Comments on Covariance Data of JENDL-4.0 and ENDF/B-VII.1

April 22, 2014

M. Ishikawa, JAEA

U-238 Capture (1/3)

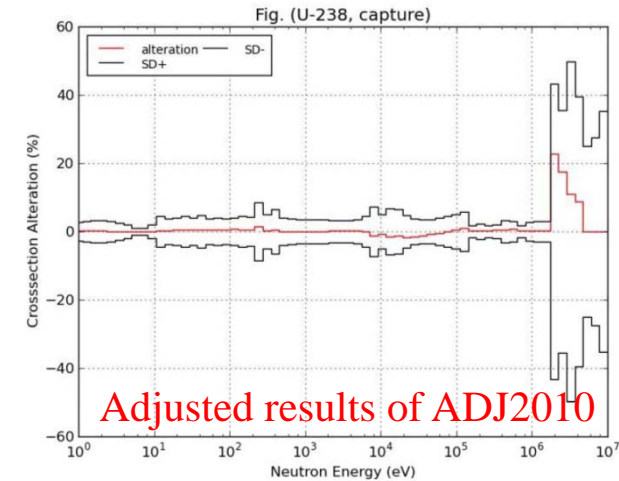
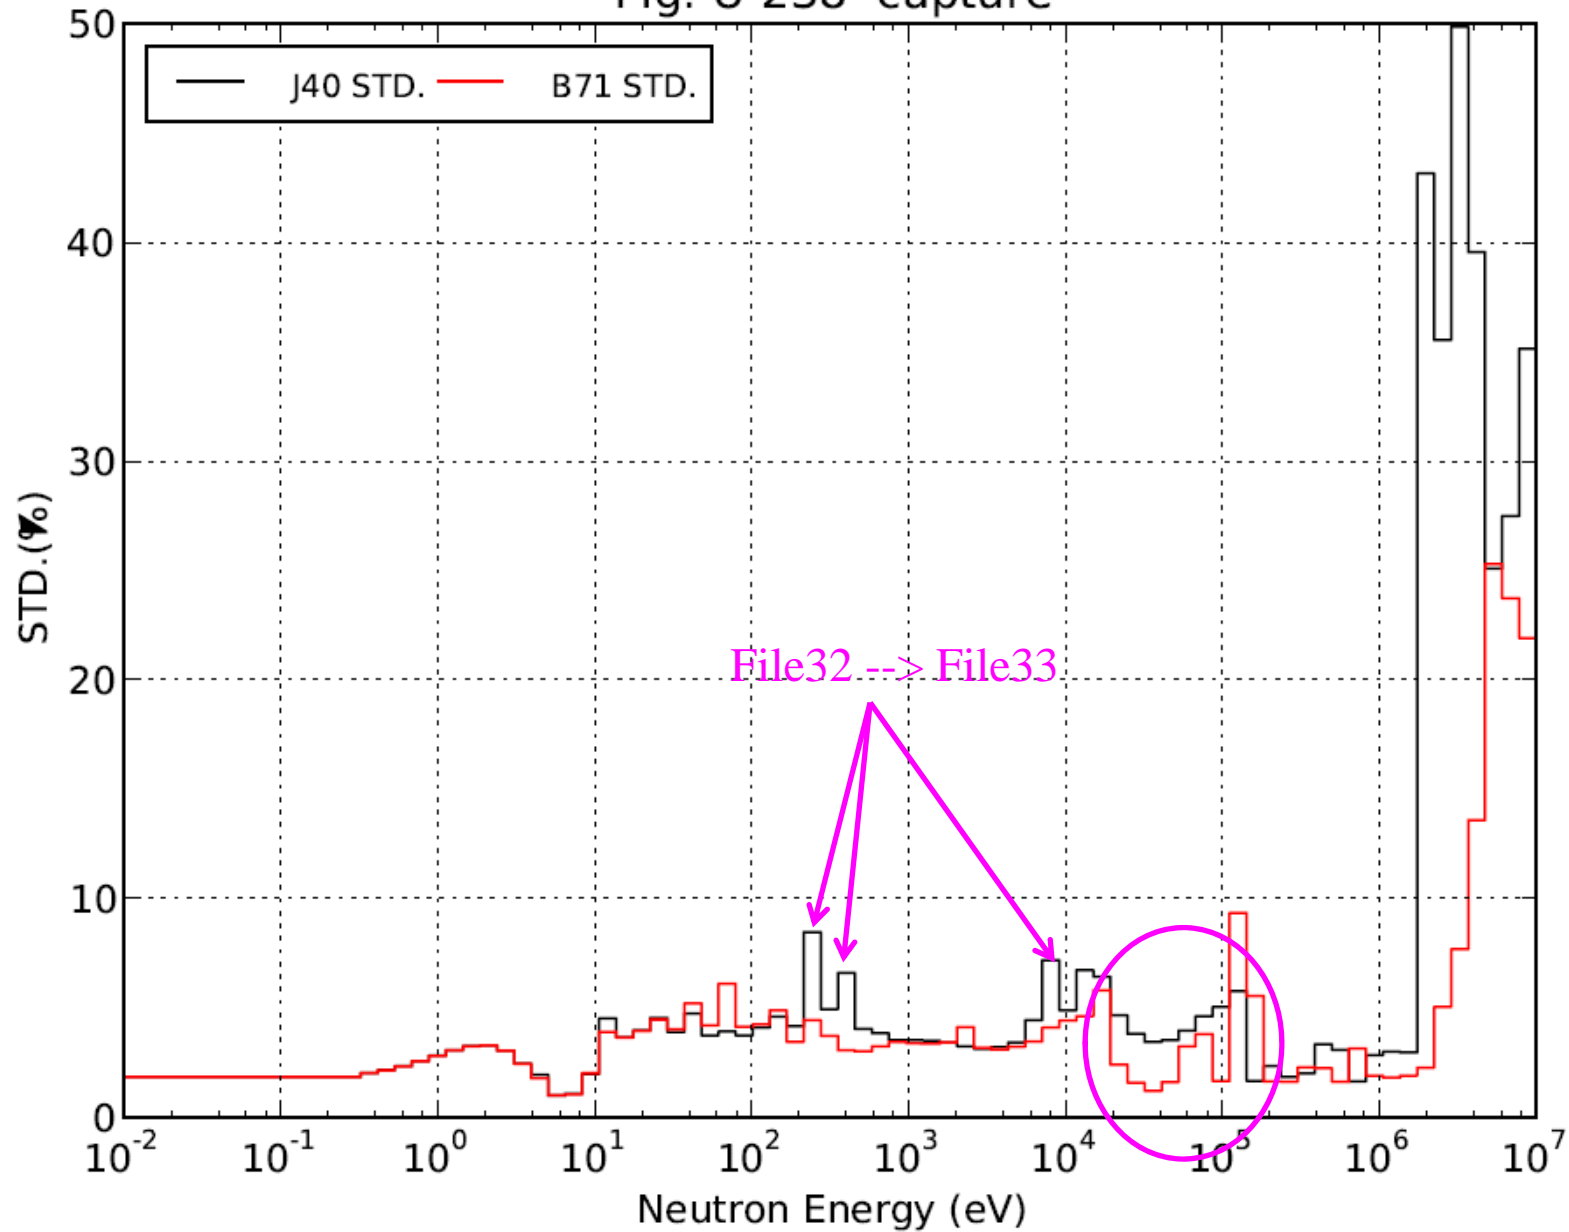
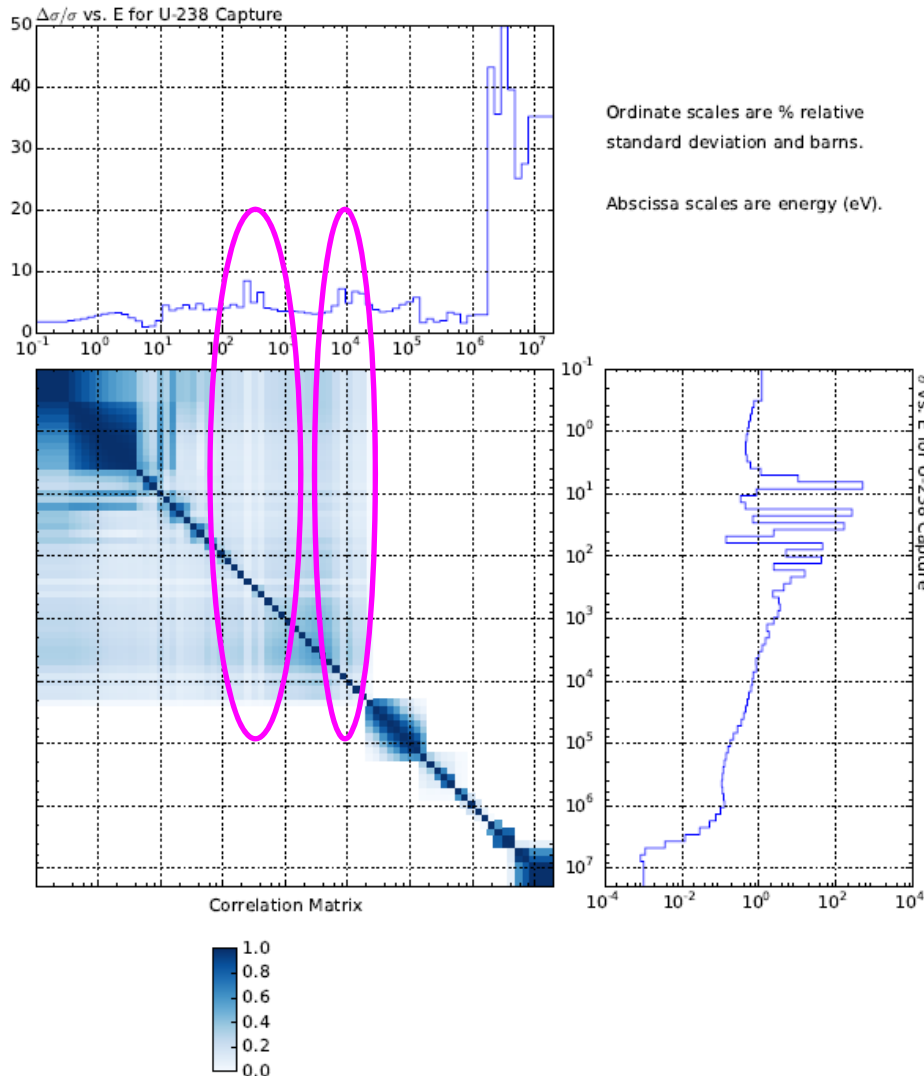
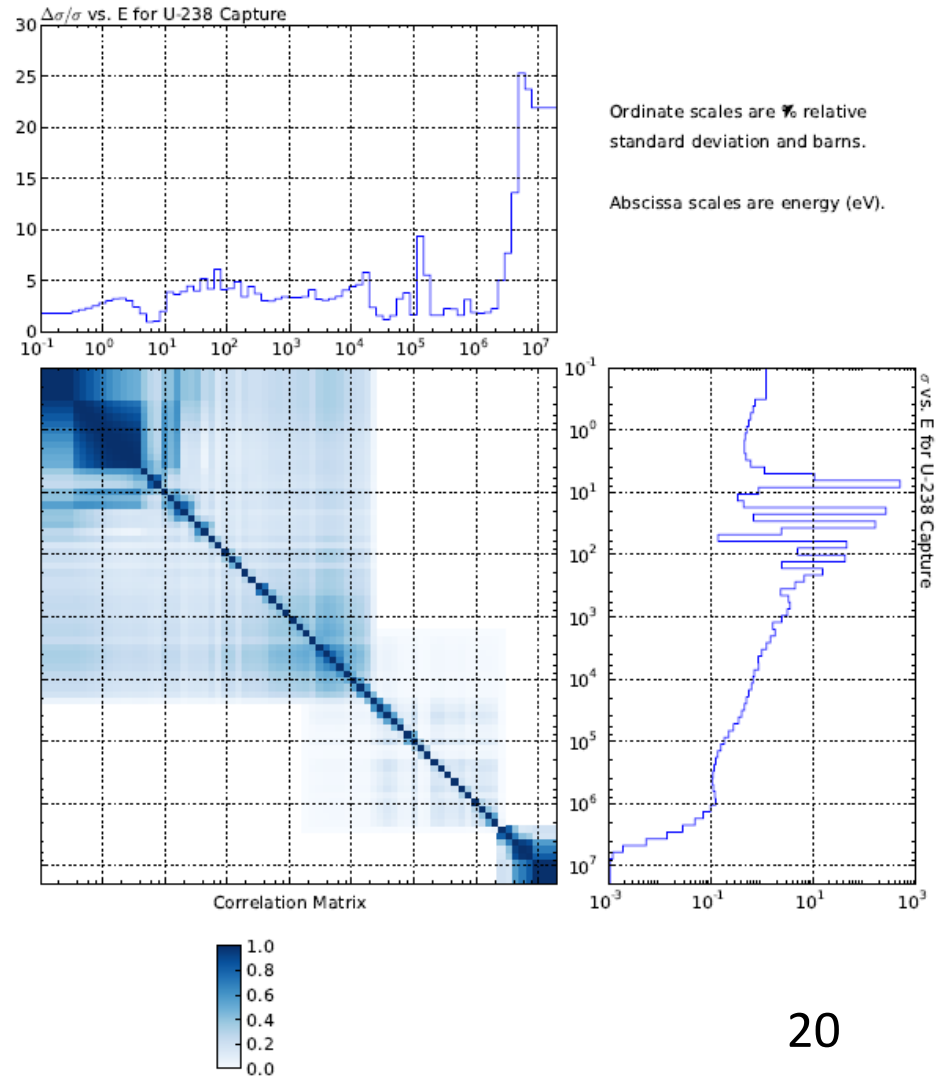
- 1) The covariance **below 20keV** is **almost identical** between JENDL-4.0 and ENDF-7., but the **spikes of STD** appears only in **JENDL-4.0**.
- 2) In the unresolved region of **20~100keV**, the **STD of JENDL-4.0** is significantly **larger** than that of **ENDF-7.1**, and **vice versa in 100~150keV**.

- 1) Both JENDL-4.0^(J-3) and ENDF-7.1^(E-2, p.20) adopted the same resonance parameters obtained from ORNL, and converted it to File 33. The process from File 32 to File 33 has some arbitrariness such as energy boundaries, therefore, some differences are possible even if the resonance parameters are identical^(J-6).
- 2) The U-238 capture in the energy range of 20~150keV greatly affects the breeding ratio or burnup reactivity loss of fast reactors, therefore, these differences are very important. The covariance of JENDL-4.0 resonance parameters was evaluated with ASREP-KALMAN in 1997^(J-4, p.13), but the details are not recorded.

SG39 should ask the **reason of item 2)** to both **JENDL-4.0** and **ENDF-7.1** evaluators.

U-238 Inelastic (1/3)

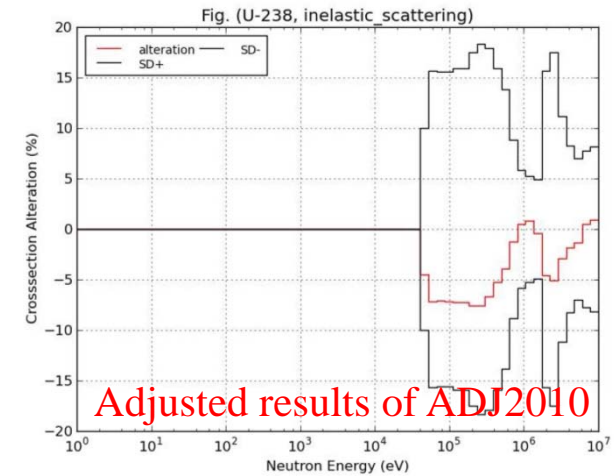
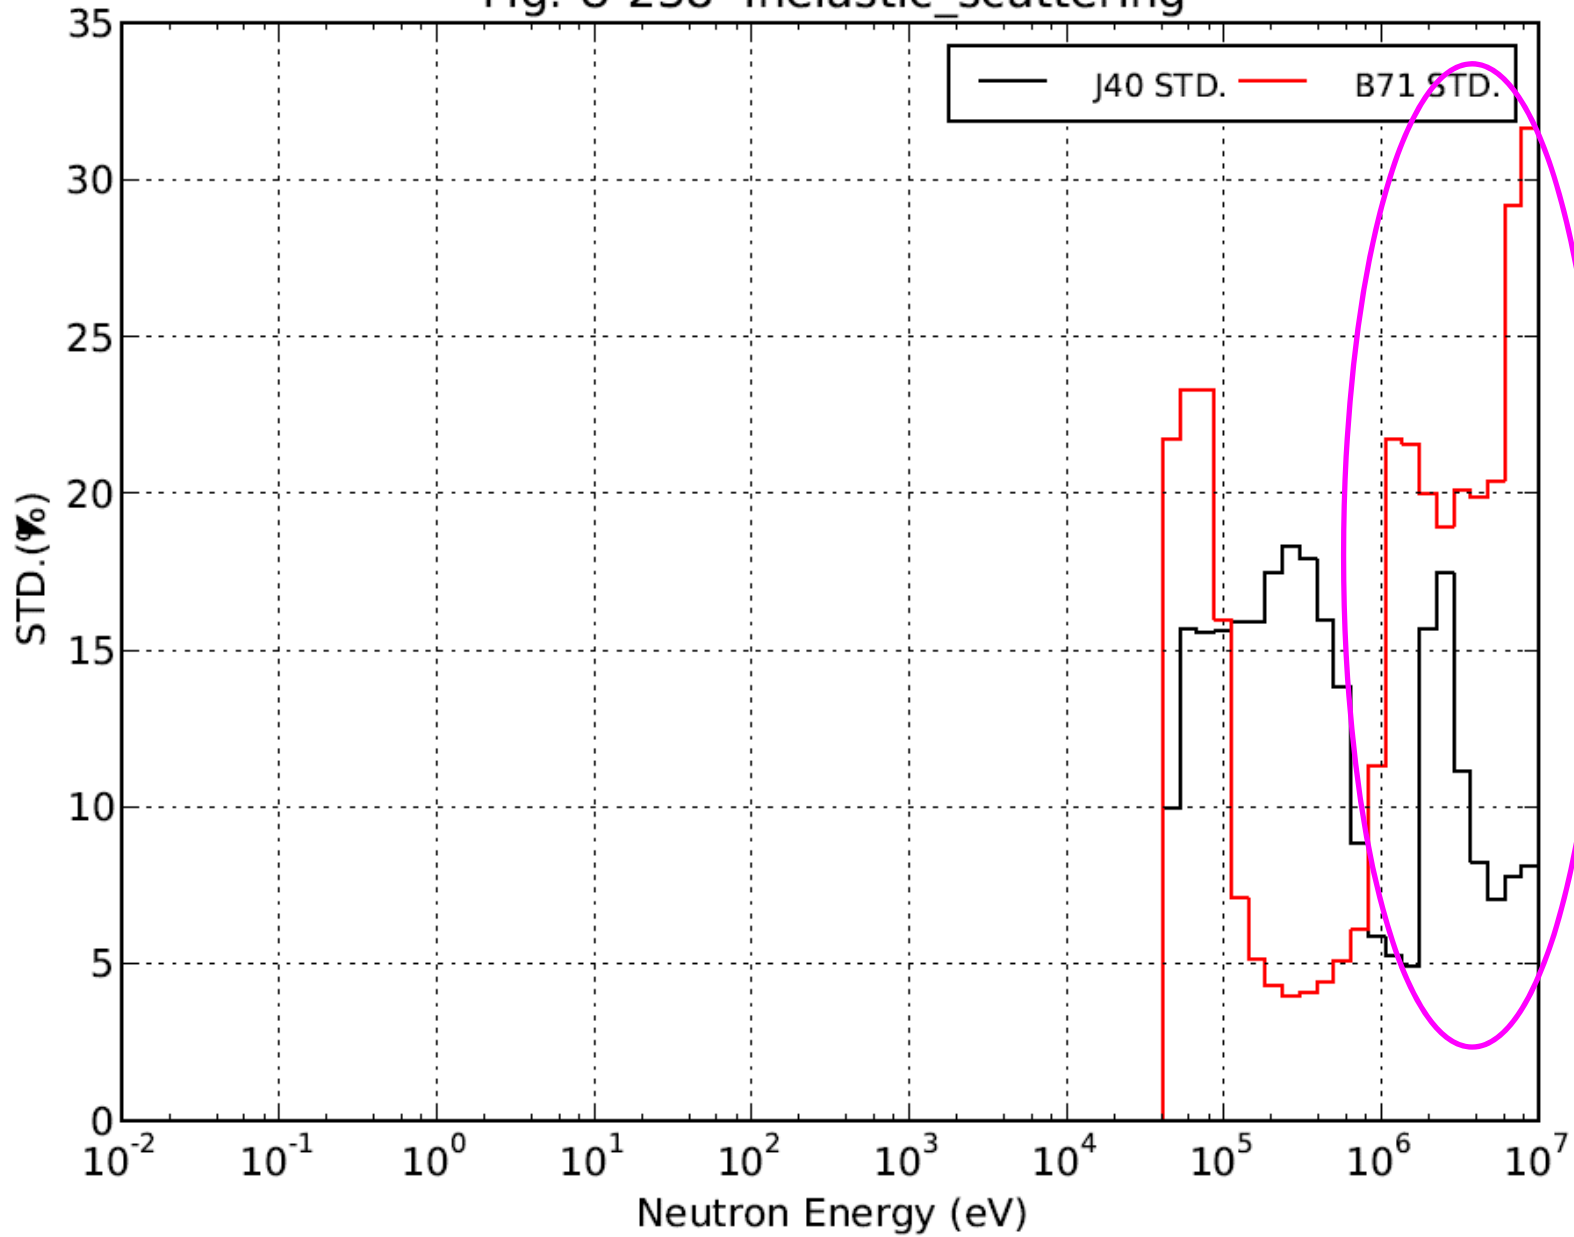
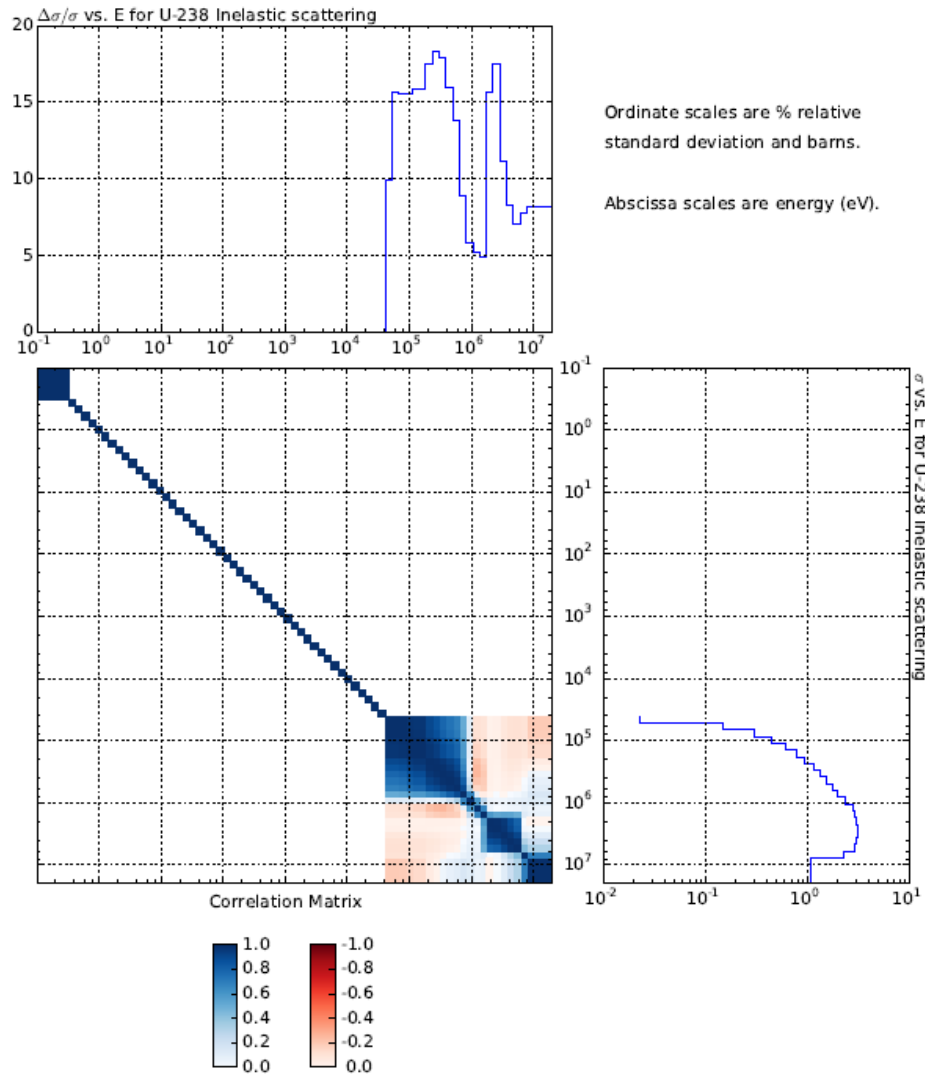
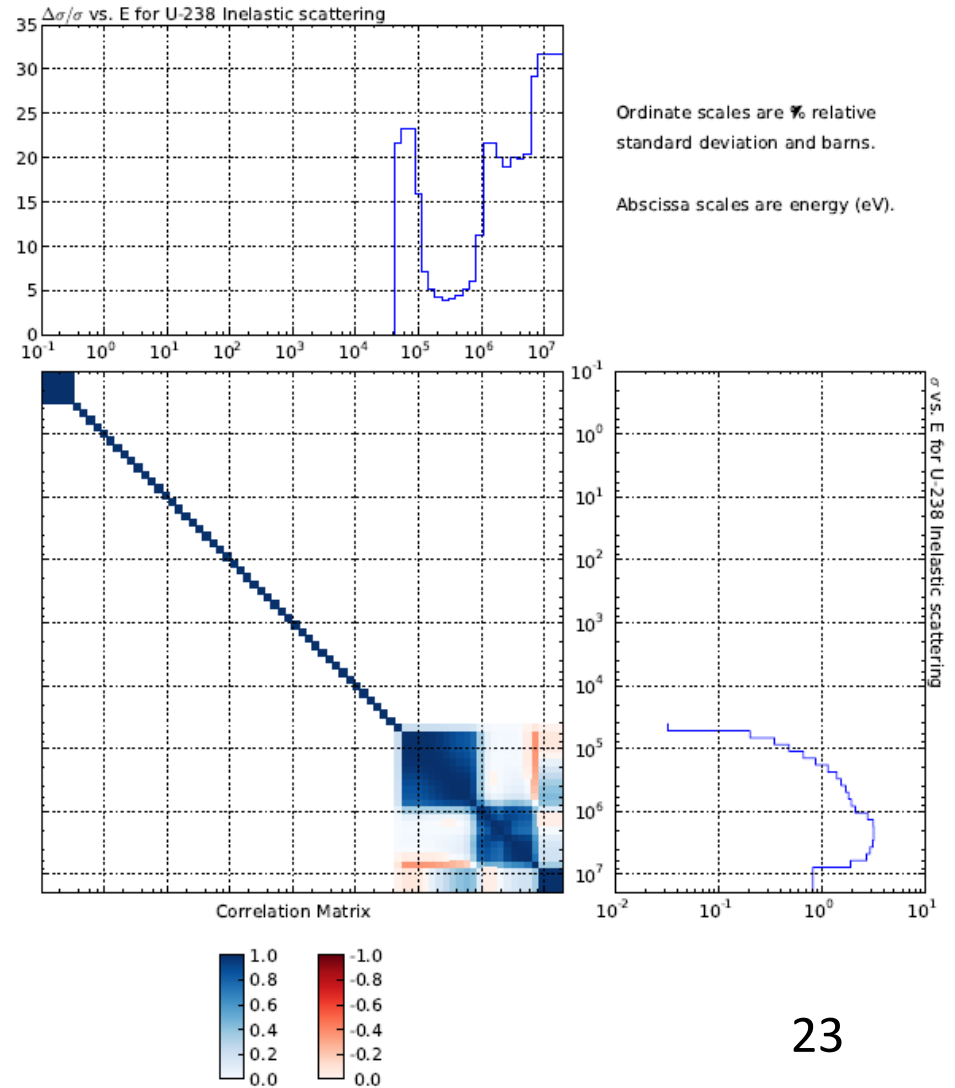
The total inelastic **cross-sections** of **JENDL-4.0** and **ENDF-7.1** seems **quite similar**, but the **STD values and the shapes are completely different**.

A possibility was considered where the level-wise evaluation of both libraries are different but the total evaluation was similar. However, the total of inelastic cross-section is simply summation of each level-wise unlike the relation between the total and the elastic cross-section case, therefore, the idea is not the reason of the differences^(J-6).

SG39 had better **consult** both **JENDL-4.0** and **ENDF-7.1 evaluators**.
